UNITED STATES  
NUCLEAR REGULATORY COMMISSION  
WASHINGTON, D. C. 20555

Docket No. STN 50-437

SUBJECT: ACRS LETTER OF JULY 25, 1979 - FNP CORE LADLE DESIGN

STAFF REVIEW AND EVALUATION  
OF  
OFFSHORE POWER SYSTEMS  
RESPONSE TO ACRS LETTER OF JULY 25, 1979

FIGURE 1 POOL TEMPERATURE HISTORIES PREDICTED BY MELJAC

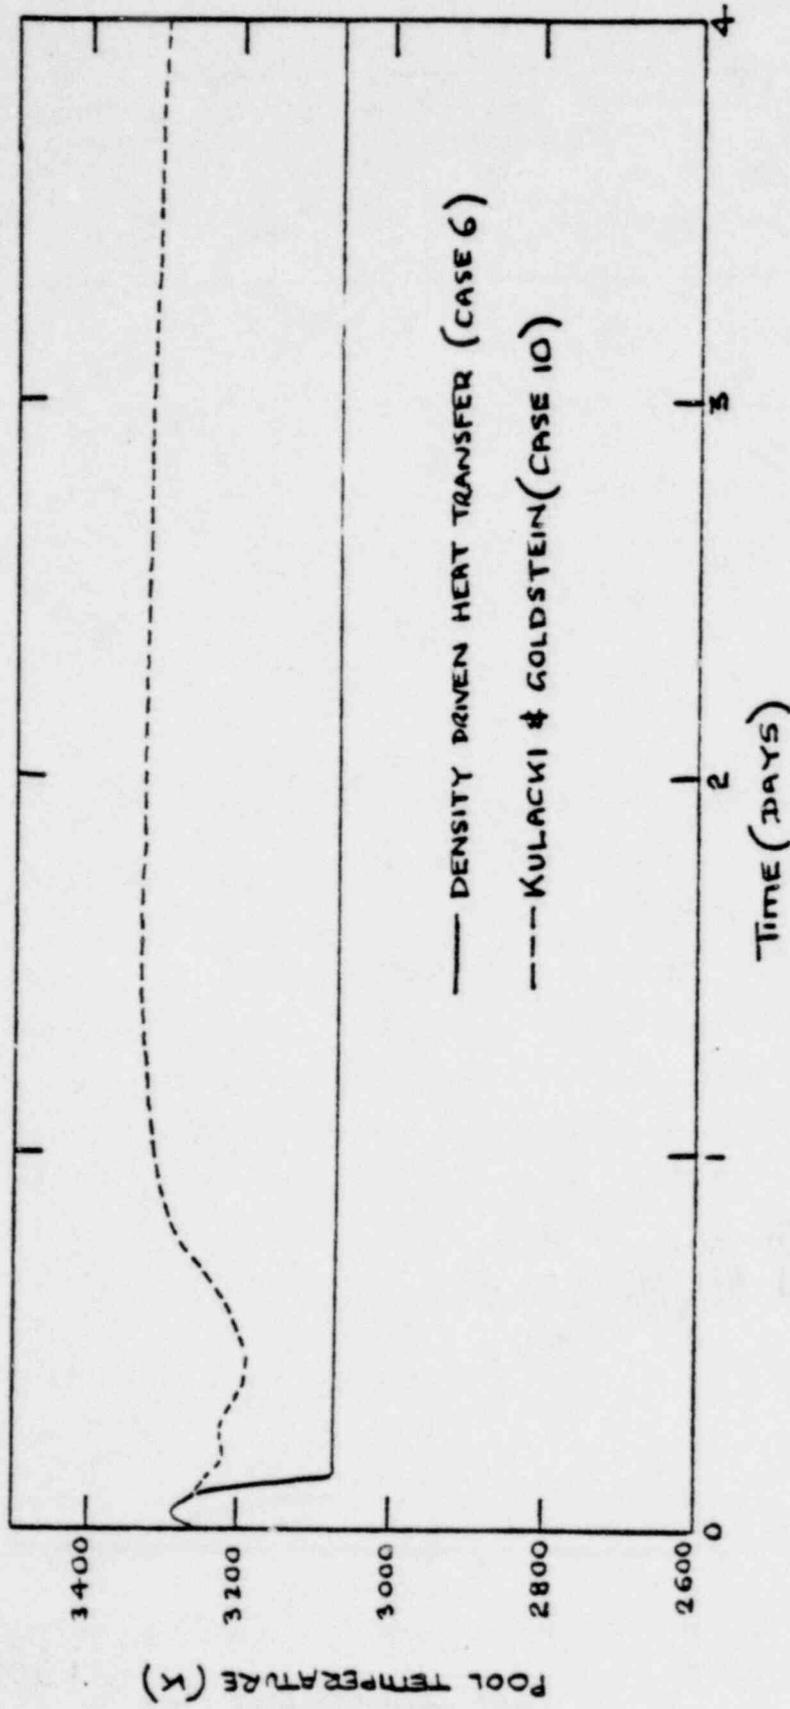
The temperatures shown in Figure 1 are the bulk pool temperature; the upper pool surface temperature is typically 80 to 100 K below this value. The effect of the higher surface temperature history predicted by MELSAC is to transfer more heat to the upper structures. A typical run (Case B) using MELSAC is compared with the results provided by OPS in Figure 2. After one day the fraction of heat stored in the walls and vessel ranges from 0.24 to 0.46 using OPS assumptions, whereas MELSAC predicts the heat stored to be 0.76. Similarly, after 5.79 days (melt-through for Case B) MELSAC predicts a fraction of 0.5 in the walls and vessel compared with 0.11 and 0.17 at 6 days using OPS assumptions. The result of this additional heat transfer to the walls is that MELSAC predicts (Case A) that the concrete in the cavity wall (24" MgO, 3" gap, 21" concrete) will reach its decomposition temperature (1473 K) after only 1 day. In order to determine a wall configuration that protects the concrete (<1473 K) and steel bulkheads (<810 K) beyond the two-day period, a scoping study was carried out and the results are presented in Table 2. MELSAC, predicts (Case B) that a MgO wall of 36" thick would be required to protect the concrete and steel for 2 days, given the input assumptions listed in Table 2.

FIGURE 2 \*

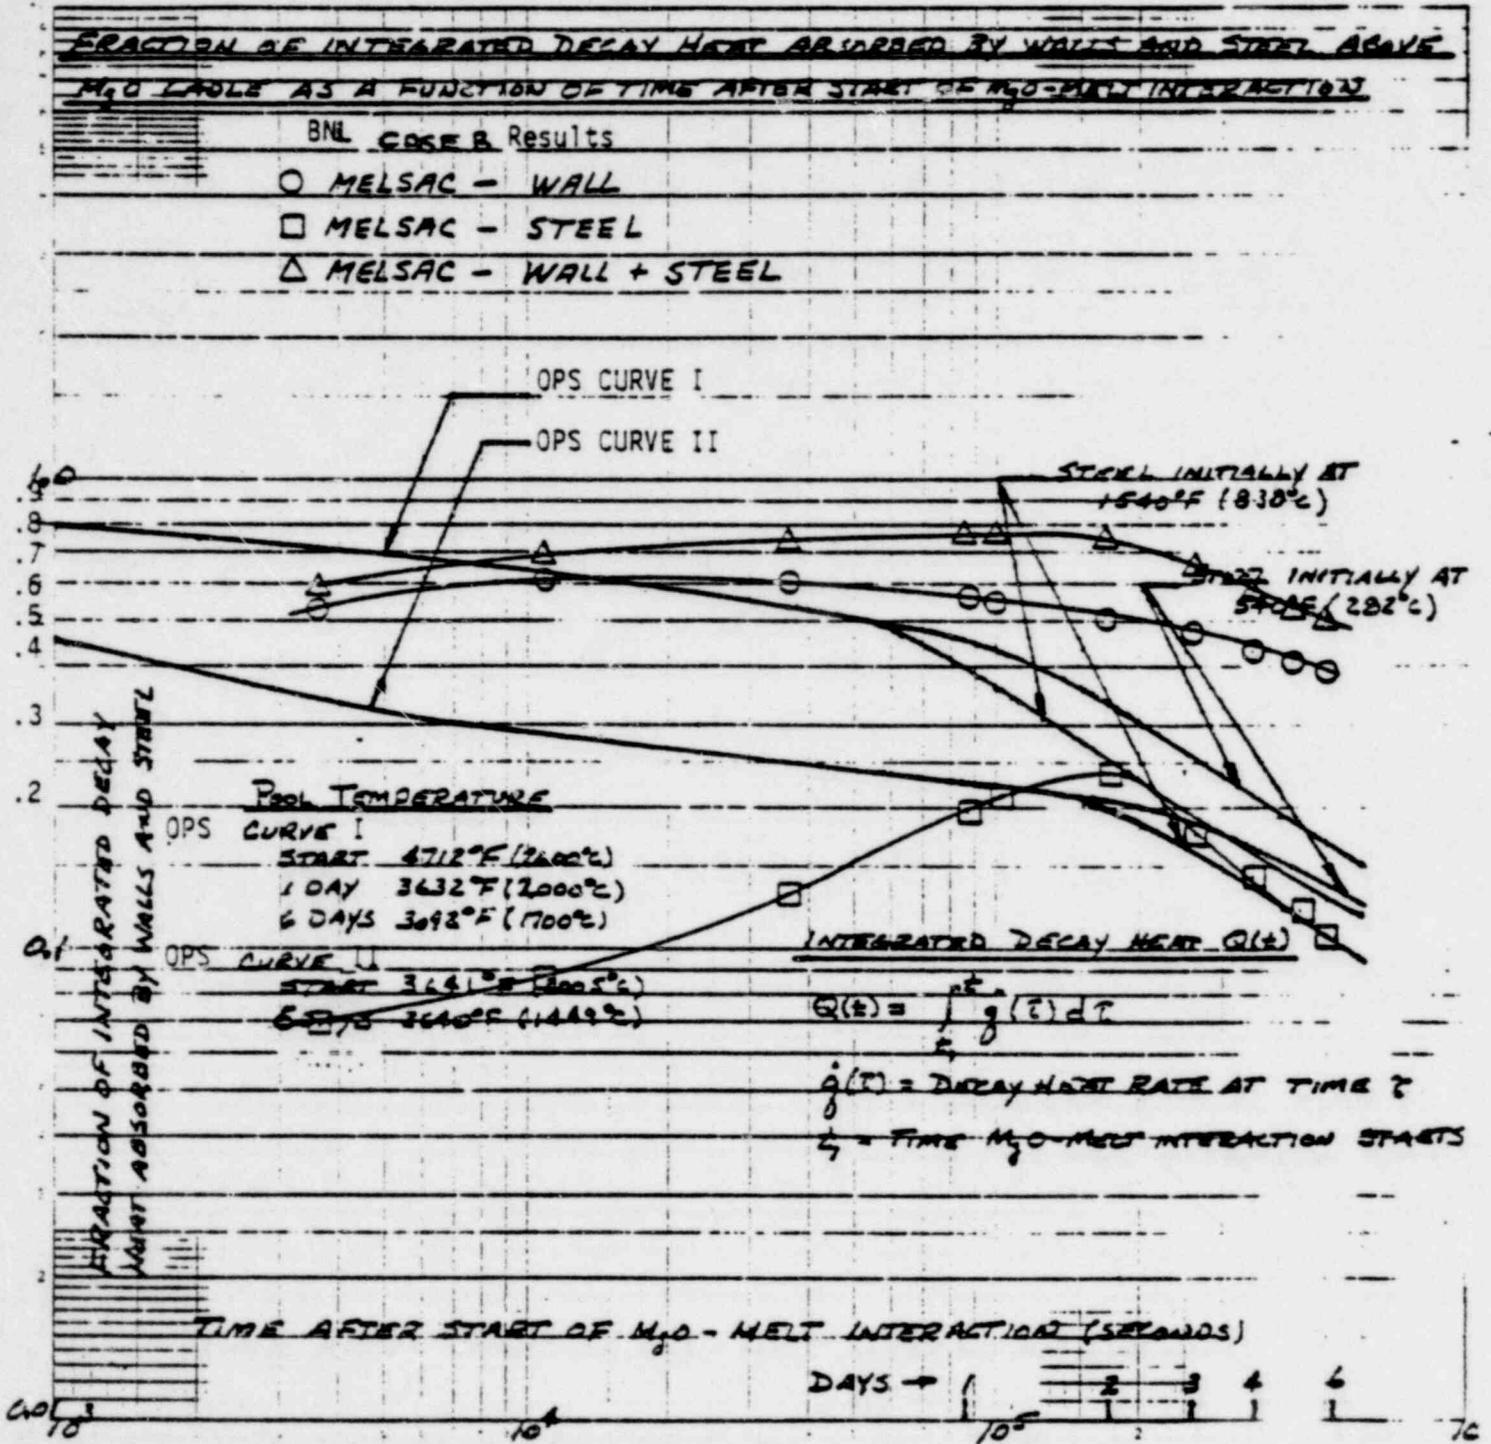
The erosion rates presented by OPS are decoupled from the upward heat transfer and were simply obtained by using a constant fraction of the volumetric heat capacity. The erosion rate predicted by MELSAC (for the wall configuration which protects the concrete and steel, namely, Case B) is compared with the OPS erosion rates in Figure 3. The MELSAC erosion rate clearly shows the coupled effect. At early times the heat transfer to the upper structures is high (because of the large temperature differences) allowing only a small fraction ( $F$ ) of the decay heat to be directed into the MgO. At later times, the upper structures are at higher temperatures and the upward heat transfer is reduced allowing half ( $F = 0.5$ ) of the decay heat to be directed into the MgO at the point of melt-through (5.79 days). This is consistent with Figure 2 in which the fraction of decay heat stored in the walls is predicted to be 0.5 at 5.79 days.

Figure 3<sup>10</sup>\*

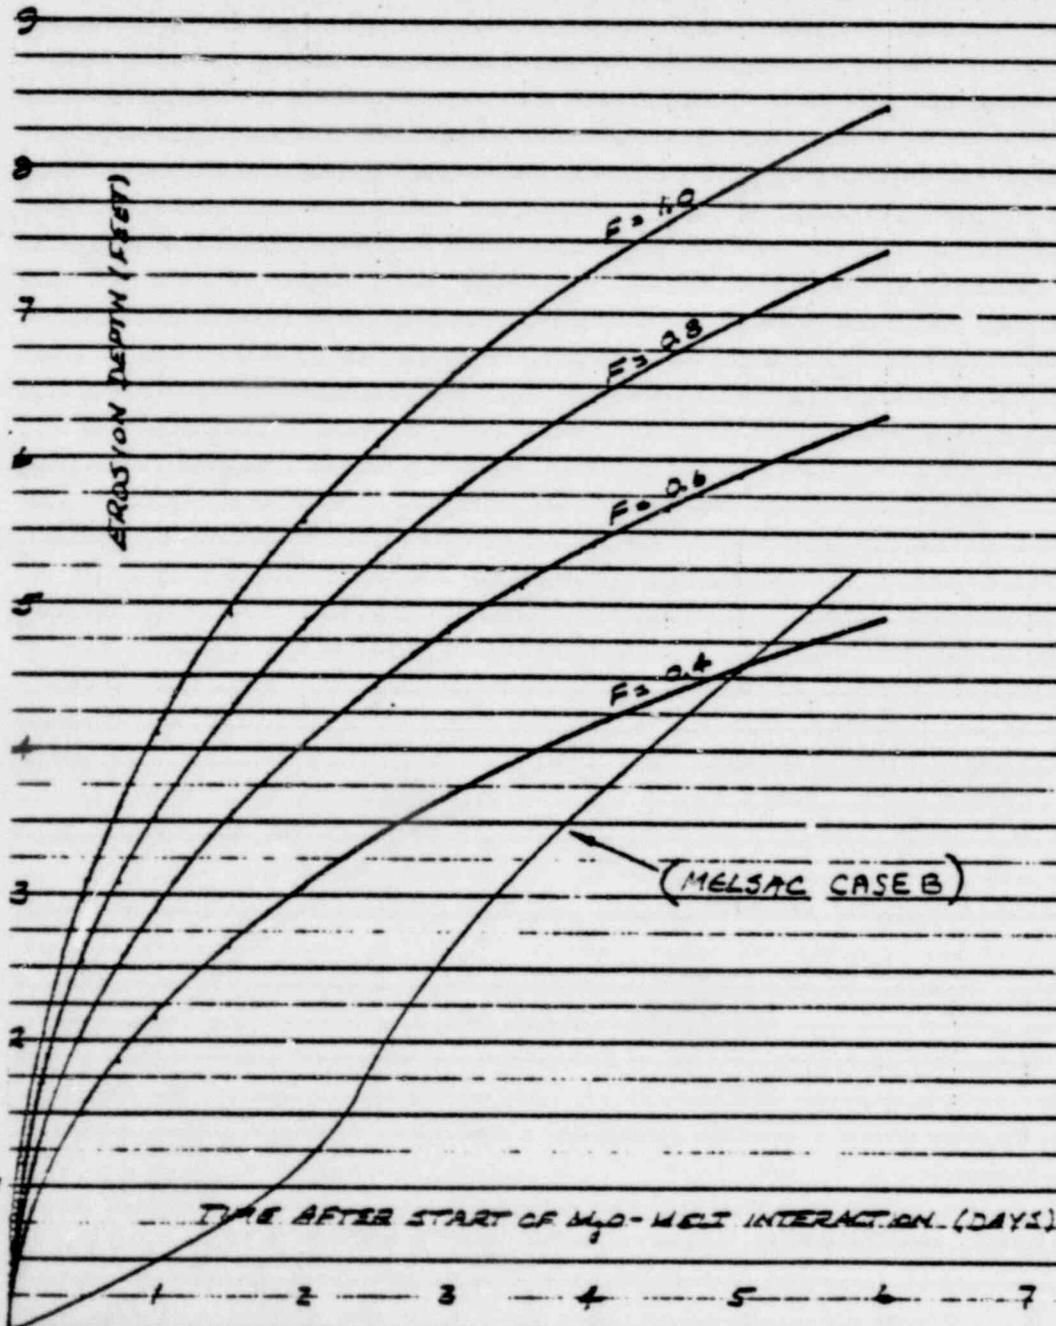
We agree with the response and it is also our understanding that the high lateral erosion rates observed during penetration of concrete is due to gas generation. The concrete results are obviously not applicable to erosion of MgO.
